CONTRACT CHANGE ORDER NO. ____
SHEET ___ OF ___

MARK	DATE	DESCRIPTIONS	BY	CH'D	CCO#
3	09/01/11	EAST END OBG	MN	DT	87
2	11/05/10	PP119 ACCESS & PP125 PLATES	MN	GB	86
1	04/09/10	HINGE A MODIFICATIONS	MN	GB	120

SAN FRANCISCO OAKLAND BAY BRIDGE
EAST SPAN SEISMIC SAFETY PROJECT
SELF-ANCHORED SUSPENSION BRIDGE
(SUPERSTRUCTURE & TOWER)

GIRDER AT EAST TRANSITION NO. 12

FACES A, F, G and L
("E" Line Shown, "W" Line Similar)
TOP GIRDER FACE LAYOUT
1:100

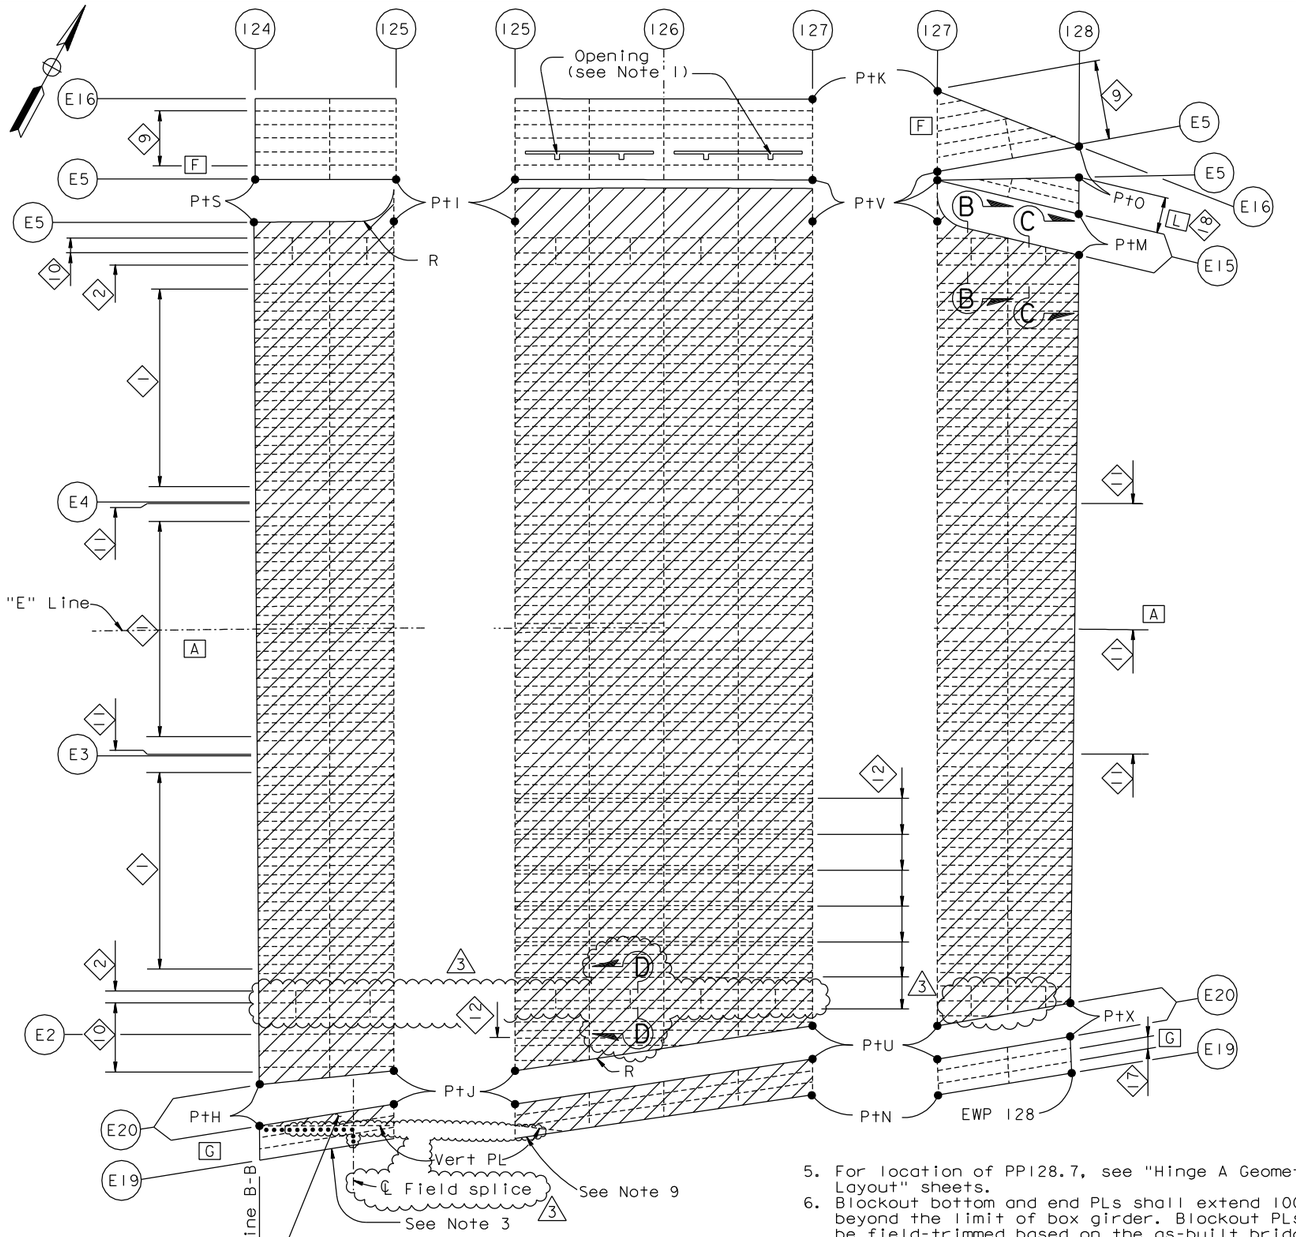
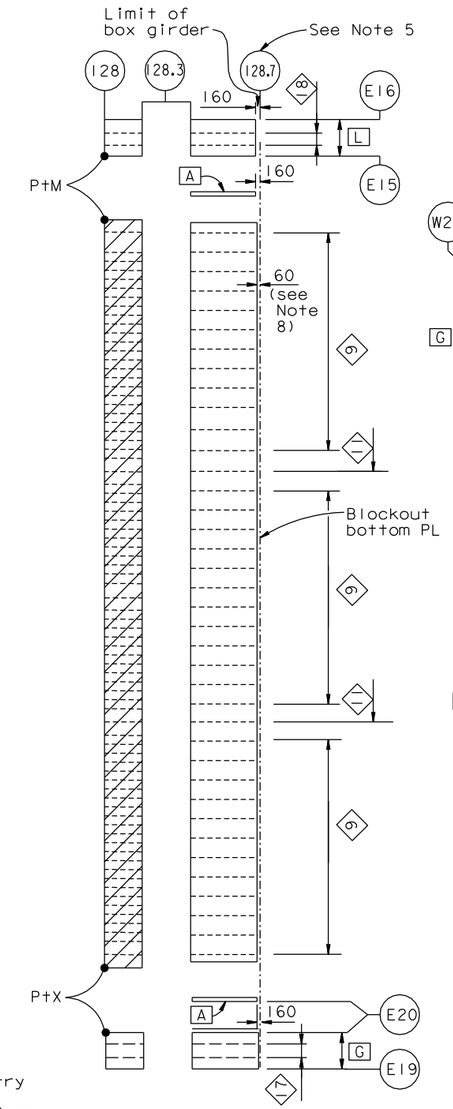
7. For Sections B-B, C-C & D-D △3, see "Girder at East Transition No.12A" sheet.
8. Plates inboard of the architectural △3 splice shall be SPCM. Thickness of architectural housing shall be taken from "Girder at East Transition Details No.3A" sheet.

9. △3 Thickness of non-SPCM PL shall be taken from "Girder at East Transition Details No.3A" sheet.
10. For stiffener termination at architectural splice, see "Typical Girder Details No.16" sheet.
